UNITED STATES PATENT AND TRADEMARK OFFICE

Office Action Summary	Application No. 10/516,810	Applicant(s) GELIKONOV ET AL.	
	Examiner Jonathon D. Cook	Art Unit 2886

Detailed Action

(modified figure 9)

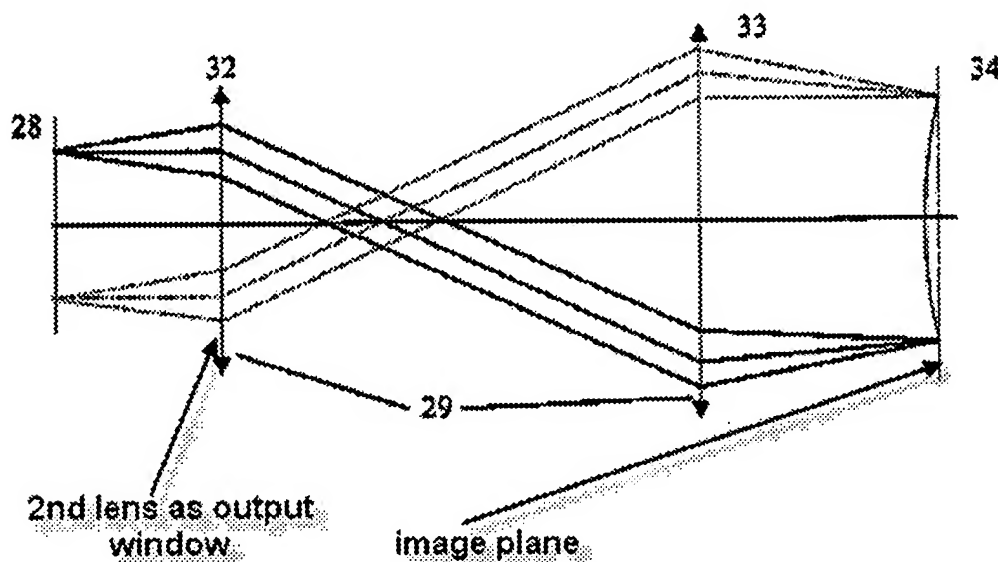
Regarding **Claims 28 & 29**, the AAPA discloses and shows in **fig. 9** (see below)

that the 2nd lens functions as the output window and is near the image plane of the end face of the distal part of the optical fiber;
